Technical Specification Group Services and System Aspects
Meeting #23, Phoenix, Arizona (USA)
15-18 March 2004

TSGS#23(04)0197

Title: CR 26.073 019 Correction of AMR DTX functionality (Release 5)

26.073 CR 019 # rev - # Current version: 5.2.0

Figure 2 Decoder output with with the original v 5.2.0 encoder

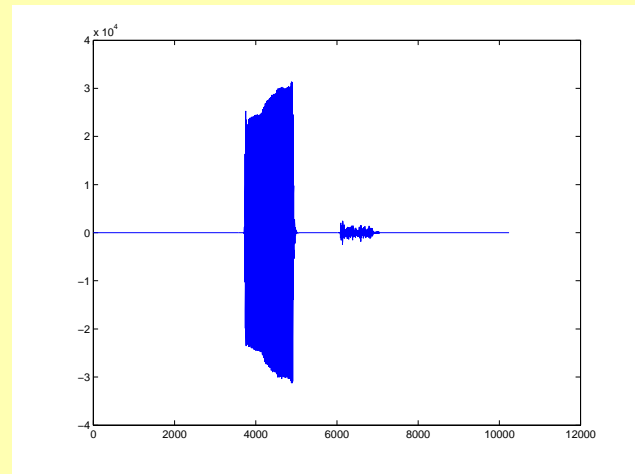
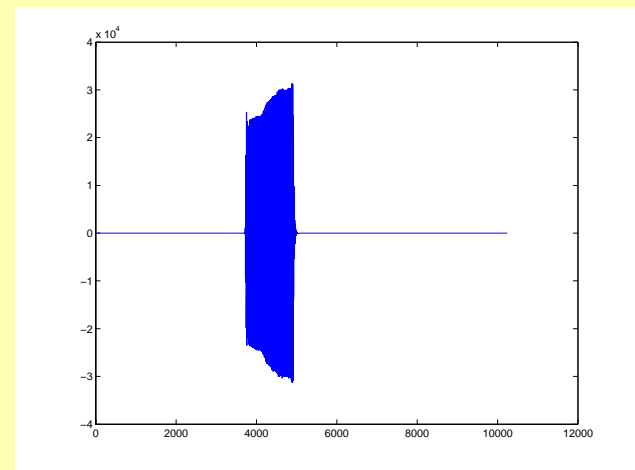
Reason for change:	# AMR codec can produce annoying output during DTX-operation.
Summary of change:	# The current AMR DTX logic overrides the DTX hangover period when the average energy of the silence or background noise before the short active tone is close to zero. The proposed correction removes this overriding. With certain short tones, the current DTX logic may produce SID frames right after the VAD algorithm has detected silence without DTX hangover period. In this case, the SID parameters (avaraged LPC and signal gain) are calculated during the tone (active signal, speech). Therefore, the comfort noise representation does not represent the true background noise or silence. The problem occurs with short tones when the signal energy is close to zero between the tones. In addition, the tone length needs to be shorter than the DTX_ELAPSED_FRAMES_THRESH, i.e. 30 frames.
Consequences if not approved:	# AMR codec output can produce annoying output with certaing signals when DTX is used.

<input type="checkbox"/>	<input checked="" type="checkbox"/>				
	<table border="1" style="display: inline-table; border-collapse: collapse;"> <tr> <td style="text-align: center;"><input type="checkbox"/></td> <td style="text-align: center;"><input checked="" type="checkbox"/></td> </tr> </table> O&M Specifications	<input type="checkbox"/>	<input checked="" type="checkbox"/>		
<input type="checkbox"/>	<input checked="" type="checkbox"/>				
Other comments:	# Example of DTX functionality. Input signal is processed with AMR encoder using mode 12.2 with DTX on. Following figures shows decoder v 5.2.0 output using the original v 5.2.0 encoder and the new encoder having corrected DTX functionality. Similar performance is achieved with all AMR modes.

Lines 163 – 167 before the change:

```
/* VOX mode computation of SID parameters */
test (); test ();
if ((computeSidFlag != 0) ||
    (st->log_en_index == 0))
{
```

Lines 163 – 167 after the change:

```
/* VOX mode computation of SID parameters */
test (); test ();
if ((computeSidFlag != 0))
{
```
